**SUSQUEHANNA STEAM ELECTRIC STATION  
APPLICATION FOR RENEWED OPERATING LICENSES  
NUMBERS NPF-14 AND NPF-22 REQUESTS FOR ADDITIONAL  
INFORMATION - LICENSE RENEWAL APPLICATION (LRA)  
ENVIRONMENTAL SITE AUDIT FOLLOWUP  
PLA-6248**

**Enclosure to PLA-6248  
PPL Responses to NRC's  
Request for Additional Information (RAI)**

Figure 2.1-3. Site Area Map

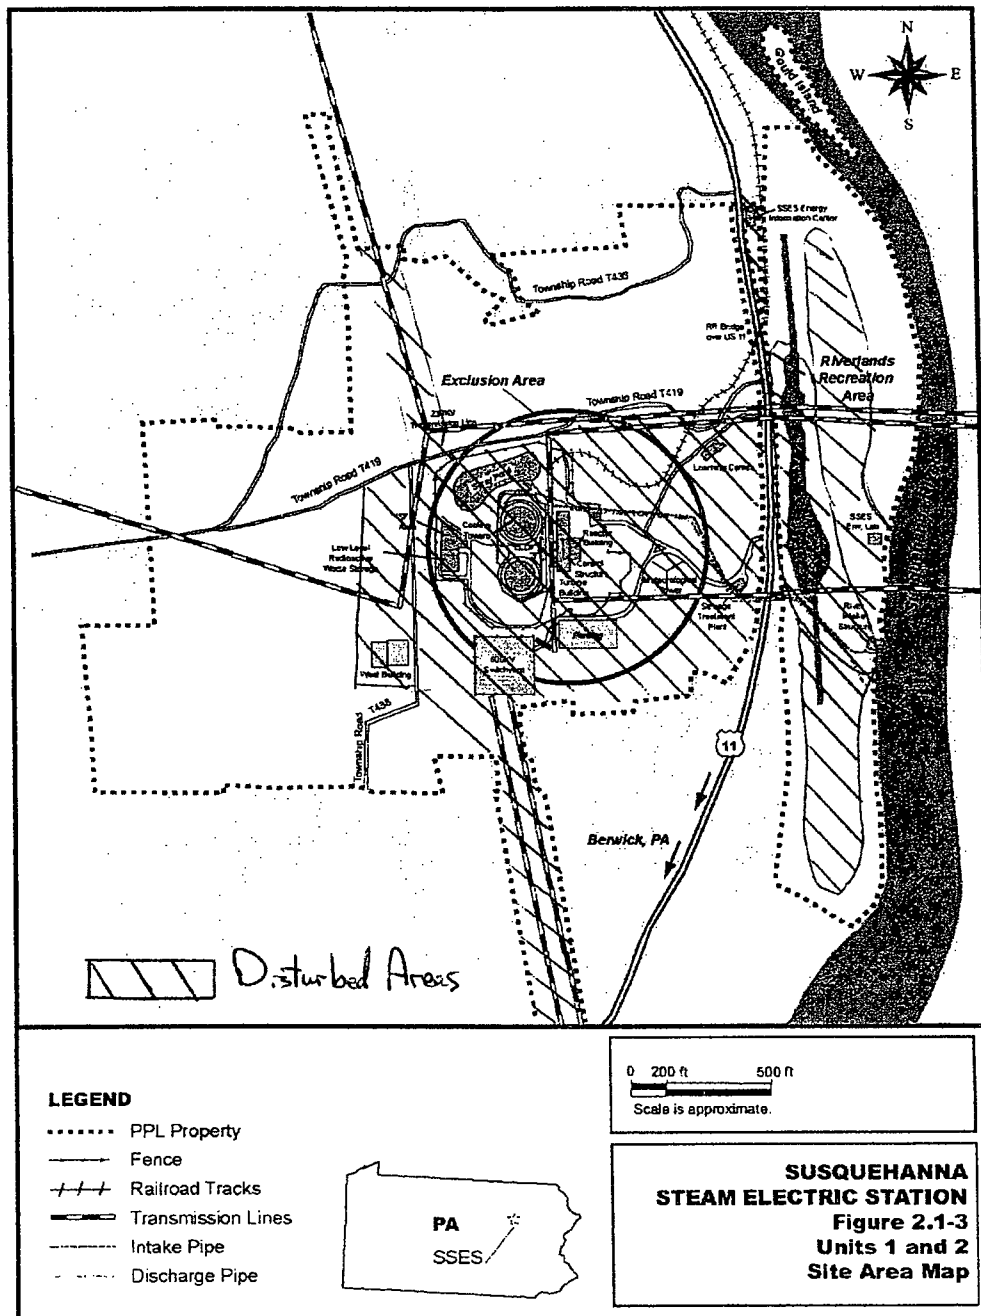
Please provide a site map and narrative indicating which areas of the SSES site have been previously disturbed. This map may be based on Figure 2.1-3 from the SSES License Renewal Environmental Report. NRC staff originally requested this information during the Cultural and Archaeological Resources interview at the environmental site audit on May 15<sup>th</sup> - 17<sup>th</sup>, 2007.

Following is a description of the SSES site areas disturbed during original and subsequent construction.

Most of the PPL property West of U.S. Route 11 bounded by Township Road T419 on the North and T438 on the West was disturbed. Some of the PPL property immediately West of Township Road T438 and bounded by Township Road T419 on the North was also disturbed. The North end of this area was used in the past as a residual waste landfill. Other areas along the West side of this road were disturbed for construction of the T10 switchyard and the "West" Building.

East of U.S. Route 11, several areas were disturbed for construction of the parking areas and maintenance building for the Susquehanna Riverlands, Lake Took-A-While, the River Intake Structure, the Energy Information Center, and the Wetlands Nature Area flow structure, parking area and drainage pipes.

The transmission corridors were also disturbed for construction of the transmission lines. This document request originated during an interview with the NRC Cultural Resources team.

PPL Attachment #7 contains a markup of Figure 2.1-3 Site Area Map (SSES License Renewal Environmental Report) indicating which areas of the site were disturbed.
